PRODUCT SERVICE NOTIFICATION

PRODUCT SERVICE NOTIFICATION #: 01162012

SUBJECT: Inspection of all “Reserve & Main Spring-Loaded Pilot Chutes” used in SOV3 Harness/Container Systems. Specifically, inspect for missing bartacks on the bridle attachment points (BAP). **See Figures 1 & 2.**

Fig-1

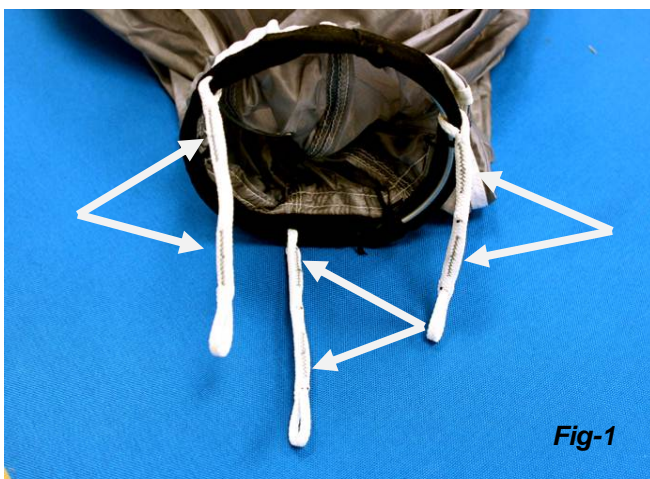
BACKGROUND: During recent inspections prior to repacking, two (2) reserve pilot chutes were discovered with one (1) missing bartack each, on the BAP at the base of the pilot chute. These components had been in regular service since 2006. As a result of this discovery, UPT researched the manufacturing records and determined that pilot chutes produced prior to May 2007 were sewn with white bartacks on the white Dacron BAPs, making the bartacks very difficult to see. Beginning in May 2007, all BAPs were bartacked with contrasting “silver” thread as shown in **Fig-2** below.

All SOV3 Harness/Containers Systems use this reserve pilot chute, while some also use it as a main pilot chute. Each pilot chute's BAPs should be closely inspected to ensure there are two (2) bartacks on each BAP. There are three (3) BAPs on each pilot chute. Refer to **Fig-1 & Fig-2** above. Arrows denote bartack locations.

When missing bartacks on the BAPs are discovered, a master parachute rigger (or military equivalent) is authorized to install, or supervise the installation of these bartacks. If a bartack machine is not available, a zigzag pattern is also acceptable. Refer to specifications below for guidance. Please fill-out and submit *Form TR425B* (the last page of this notice). Post, Fax or Email to: tk@cpsworld.com

Bartack Type: 42 stitch pattern
Length: 1" (26mm) ± 1/8" (4mm)
Thread Type: Size E, #69, T70 Nylon
Thread Color: Contrasting

Zigzag Type: Single-throw
Length: 1" (26mm) ± 1/8" (4mm)
Thread Type: Size E, #69, T70 Nylon, 10-11 Stitches per Inch, 1/8" wide. Begin sewing pattern from the center - to the end - back to the other end - finishing in the center. 46 total stitches minimum, up to 66 maximum.
Thread Color: Contrasting
